Rezoning Transportation Analysis

Petition Number: 2025-086

General Location Identifier: 10817111

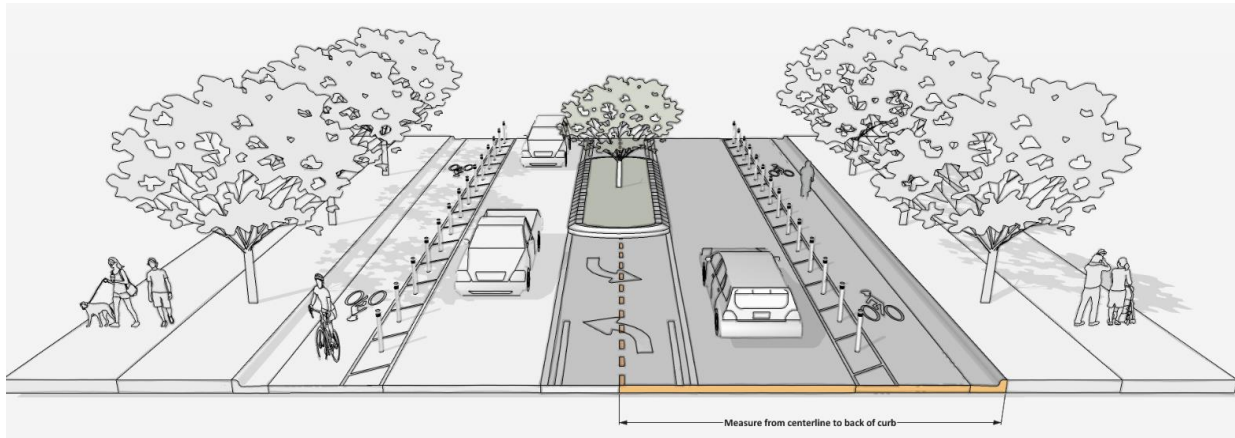
Label and dimension the curb and gutter from the centerline for each road on the site plan.

~~Clarifying comment 09-24-25: Revise site plan by placing 27-foot dimension towards your site and add a callout stating that is the proposed back of curb. Show curb and gutter being placed along sites frontage.~~

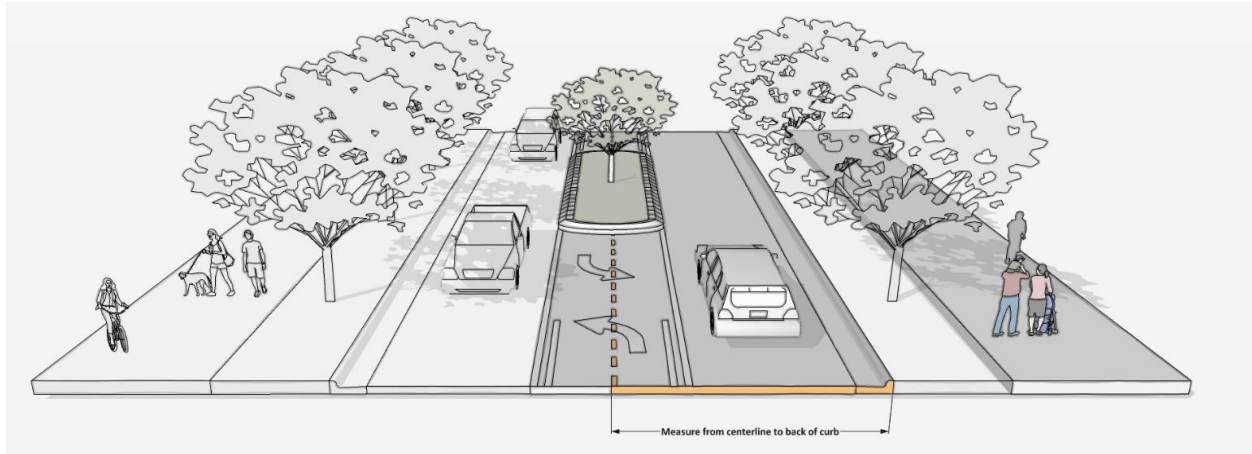
3. ~~Revise site plan and conditional note(s) to commit to dedicate 43 feet of right of way from the road way centerline of Pence Road. The site plan shall label and dimension the right of way from the roadway centerline.~~
4. ~~Revise site plan and conditional note(s) to commit to construct bicycle facilities by locating the curb and gutter 27 feet from the center line in accordance with the council-adopted Charlotte Streets Map. Site plan to label and dimension buffered bike lane on the site plan.~~

Clarifying comment 09-24-25: Revise site plan and conditional note(s) by showing a 5-foot bike lane and 3-foot buffer. Callout striping on the site plan and revise condition note(s) to commit to installing the bike lane per Charlotte Streets Map. Currently the 27-foot dimension is towards the opposite side of the road.

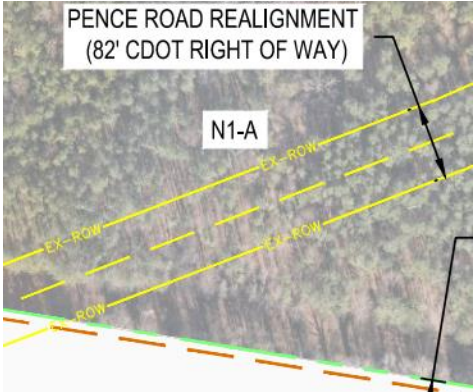
Clarifying comment 01-21-25: Line type on site plan shows "EX-ROW". Revise line type to clearly show the right-of-way is not existing but is to be reserved for the future street.
